Work Order ID 159267

Item Name: Replacement Skidtube (Fits LH or RH)

DRAWING NO. D2650	TITLE 206/407 SKIDTUBE ASSEMBLIES	REV. F	DART AEROSPACE LTD ENGINEERING ORDER		D.E.O. NO. D2650-F-1	SHEET NO. SHEET 1 OF 1	SCALE NTS
DRAWN <i>[Signature]</i>	CHECKED A.P.	MFG. APPR. <i>[Signature]</i>	APPROVED <i>[Signature]</i>		DE APPR. <i>[Signature]</i>		
DATE 12.10.12	DATE 12.10.22	DATE 12.10.22	DATE 12.10.22		DATE 12.10.22

ADD DETAIL G BELOW, WHICH IS THE SAME SECTION VIEW AS DETAIL D OF DWG.

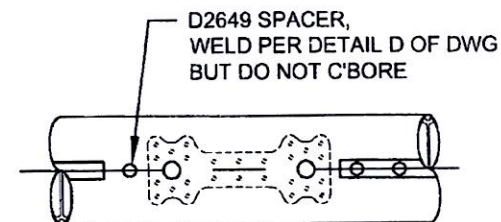
CHANGE C'BORED WELDED CROSSBOLT SPACERS TO SWAGED SPACERS

PARTS LIST IS AMENDED AS FOLLOWS:

QTY	QTY	QTY	QTY	PART NUMBER	DESCRIPTION
-1	-3	-5	-7		
1	1	0	0	D2649	CROSS BOLT SPACER
16	17	19	23	D4720-1	SPACER

17	18	19	23	D2649	CROSS BOLT SPACER
----	----	----	----	-------	-------------------

DETAIL B

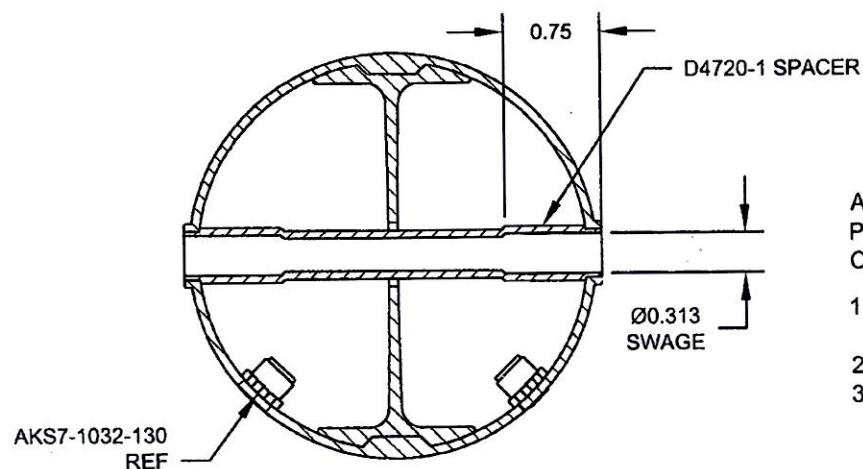
C'BORED HOLES ARE **NOW SWAGED** PER DETAIL G BELOW. FOR THE Ø0.375 HOLE THAT IS NOT C'BORED, WELD PER DETAIL D OF DWG (SEE AMENDED DETAIL B FOR REFERENCE).

AMENDMENT TO DETAIL B
NOT TO SCALE
